RE: Calico Solar (formerly Solar One) Project (08-AFC-13)
Applicant's Submittal of Alternative Site Layout #2, Engineering Figure with SunCatcher Layout,
and Revised Project Boundary with 4000' Desert Tortoise Corridor Figure

Tessera Solar hereby submits the Applicant's Alternative Site Layout #2, Engineering Figure with SunCatcher Layout, and Revised Project Boundary with 4000' Desert Tortoise Corridor Figure.

ALTERNATIVE #2 PROJECT LAYOUT WITH 4,000 FOOT DESERT TORTOISE CORRIDOR CALICO SOLAR

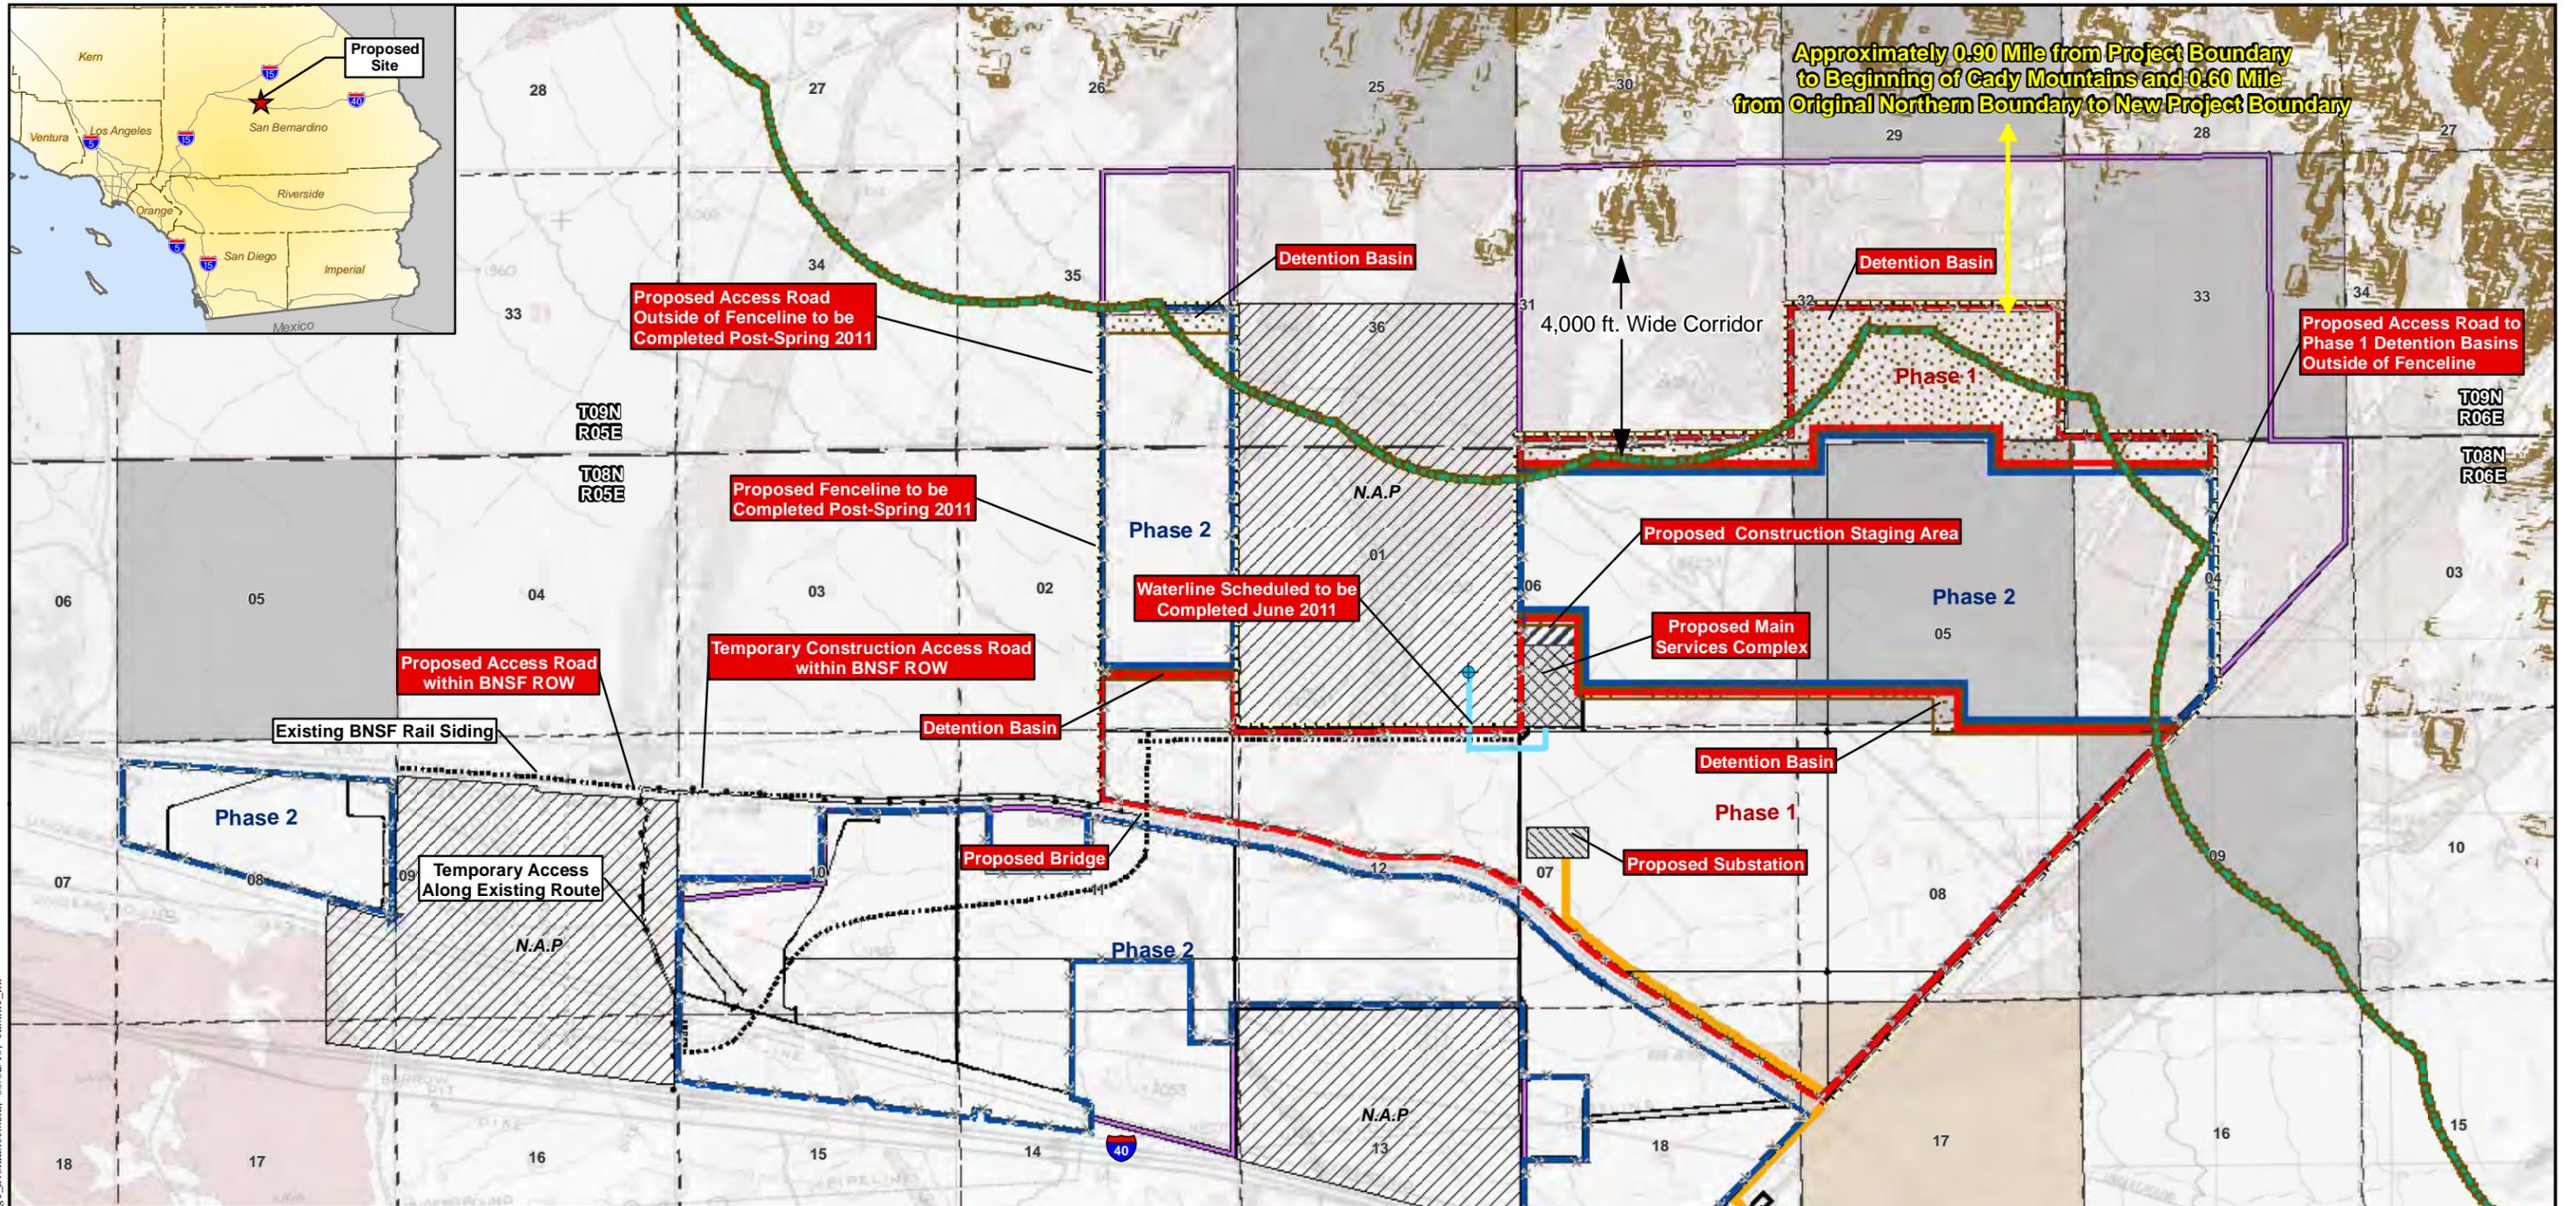
On May 14, 2010 a Supplement was filed that described modifications to the Project's northern boundary. Based on input from the U.S. Fish and Wildlife Service's Desert Tortoise Recovery Office (DTRO) and the Bureau of Land Management (BLM), the northern boundary of the Project site has been further modified to include a 4,000-foot wildlife corridor between the Project (inclusive of all detention basins) and the base of the Cady Mountains. To accommodate this modification, the detention basins were re-configured to extend east to west along the northern Project boundary and the boundary between Phases 1 and 2. Through this change in detention basin design, two objectives are achieved: the detention basins are included within the Project fenceline and outside of the 4,000-foot wildlife corridor, as requested by the wildlife agencies, and the detention basin design maintains the natural drainage patterns of the site.
